DWN	DATE 08/15/2013		TEXAS IN	STRUMENTS	
		ENGR	08/15/2013		© COPYRIGHT 2010 TEXAS INSTRUMENTS		
		APVD	08/15/2013		ALL RIGHTS RESERVED		
		MFG		ESD, LIGHTCRAFTER 4500			
N/A	0314PO	QA					
NEXT ASSY	USED ON			A3	DRAWING NO 2512	2909	REV E
APPLICATION		sw Allegro Design E	ntry 16.5	SCALE		SHEET 1 of 29	1

Schematic Revision History

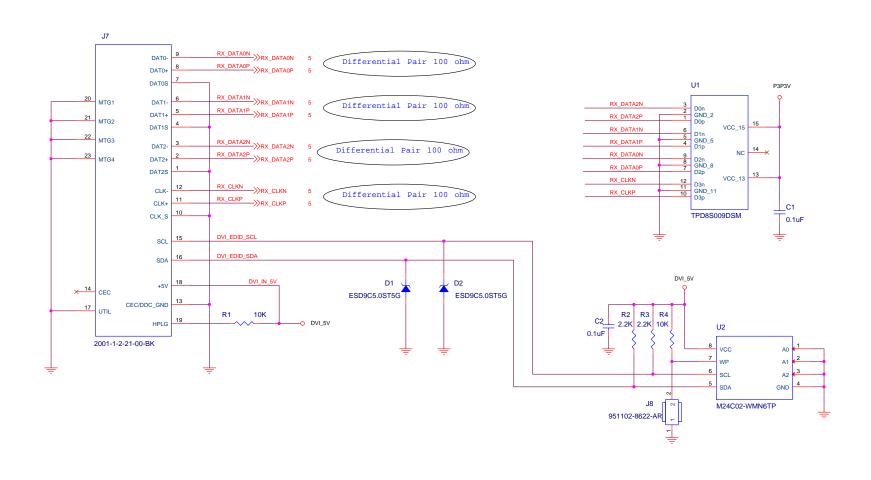
New reference designators have been added D15, and D16. changes on page 16 and 23. MR 1/11/2017.
- 4) Original D10 part discontinued, Changed D10 from MAZ80330HL to DZ2J033M0L page 23. MR 1/11/2017.
- 5) Original J7 part discontinued, Changed J7 from MHDMI-19-02-H-TH-L-TR to 2001-1-2-21-00-BK page 4. MR 1/11/2017.

Panda to LightCrafter 4500 Connections

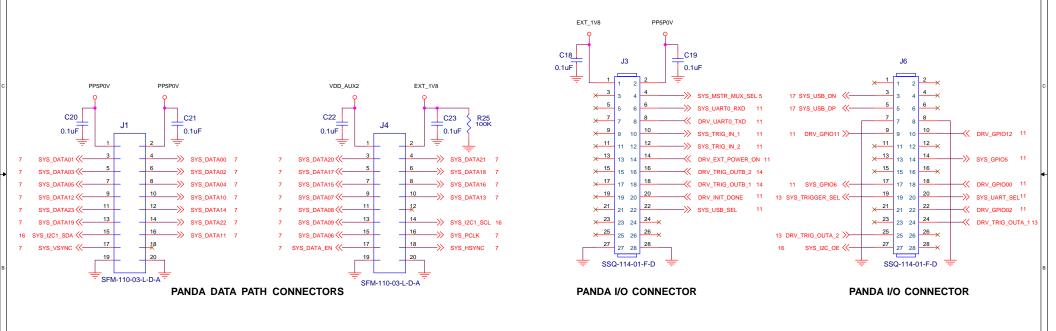
Sheet 7

1) Add Panda interface connection block diagram

Power Management Block Diagram

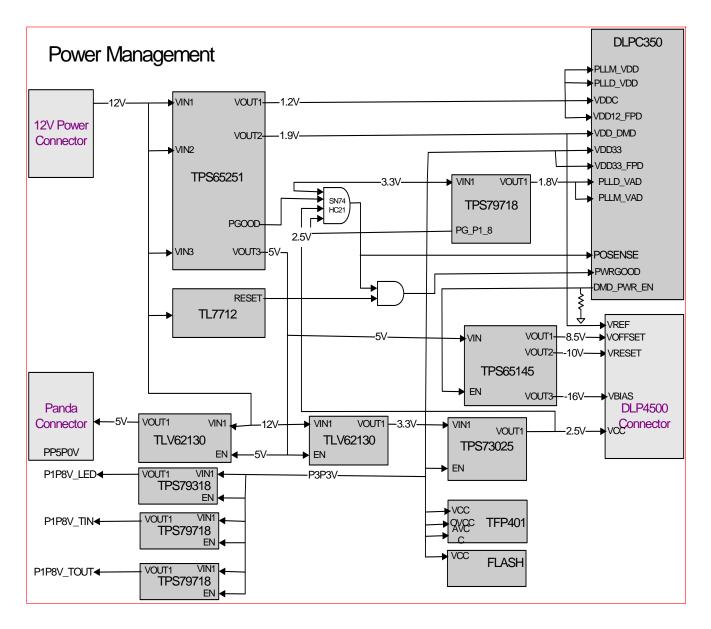
Sheet 21

1) Up-date power management block diagram

Input Power and Oscillator Input

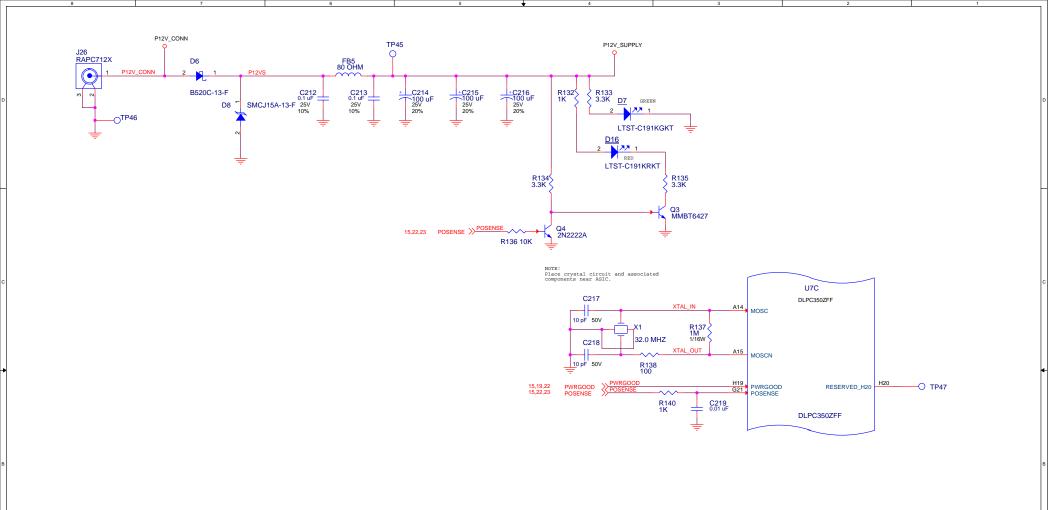
- 3) Original components used for D4 and D7 have been discontinued by manufacturer. A single diode solution is now in place for D4 and D7.
